FORM APPROVED
OMB NO. 1004-0135
Expires: July 31, 2010**SUNDRY NOTICES AND REPORTS ON WELLS**
*Do not use this form for proposals to drill or to re-enter an abandoned well. Use form 3160-3 (APD) for such proposals.*5. Lease Serial No.
NMNM0354232

☐ Oil Well ☒ Gas Well ☐ Other8. Well Name and No.
ELIZONDO A 3

9. API Well No.
30-015-21930-00-S1

Temporary Abandonment of Wells on Federal Lands
Conditions of Approval

OXY USA WTP LP - Proposed
Elizondo A Federal #3
API No. 30-015-21930

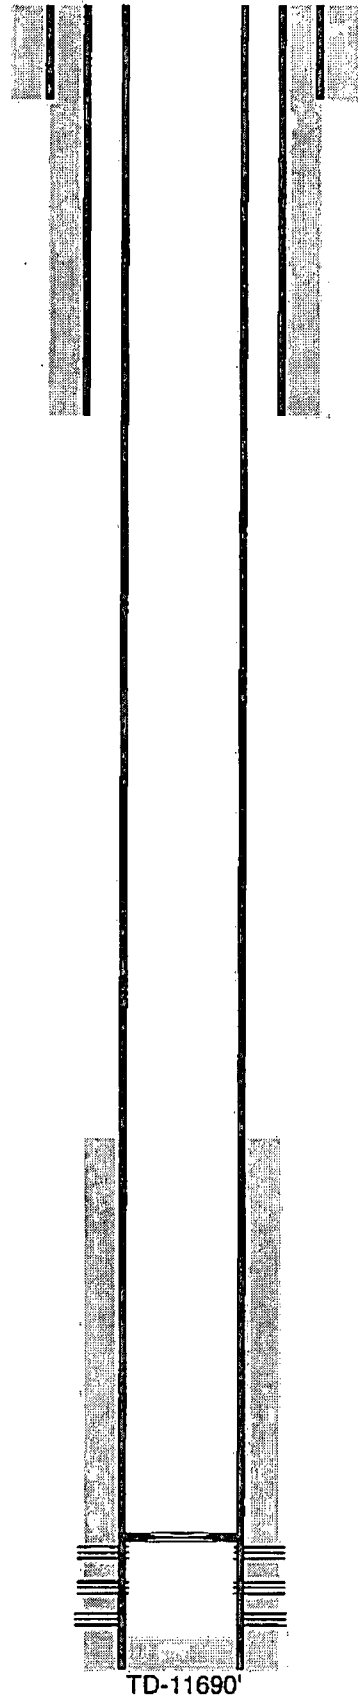
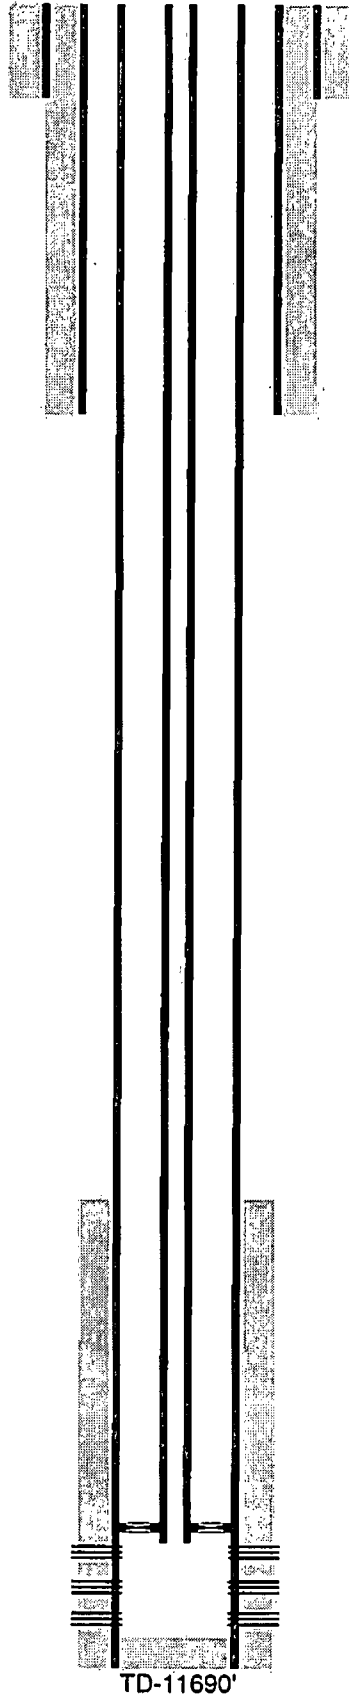
1. POOH w/ prod equipment, RIH & set CIBP @ +/-10975'.
2. Notify BLM/NMOCD of casing integrity test 24hrs in advance.
3. RU pump truck, circulate well with treated water, pressure test casing to 500# for 30 min.

- a. A bridge plug or packer must be installed as close to 50 feet above any open perforations or open hole as possible. The bridge plug is to be capped with 35 feet of cement (if bailed) or 25 sacks (if placed with tubing). If a cement plug is used, the top of the cement must be verified by tagging.

- b. The wellbore must be filled with corrosion inhibited fluid and pressure tested to 500 psi. The casing shall be capable of holding this pressure for at least 30 minutes with a 10% allowable leakoff.

- c. All downhole production/injection equipment (tubing, rods, etc.) shall be removed from the casing if they are not isolated by a packer.
 - d. A bradenhead test must be conducted. If the test indicates a problem exists, a remedial plan and time frame for remediation shall be submitted within ninety (90) days of the test.

Submit Subsequent Report and well bore diagram with all Perforations and CIBP with tops of cement. Well may be approved to be TA for a period of 1 year after successful MIT and subsequent report is submitted.
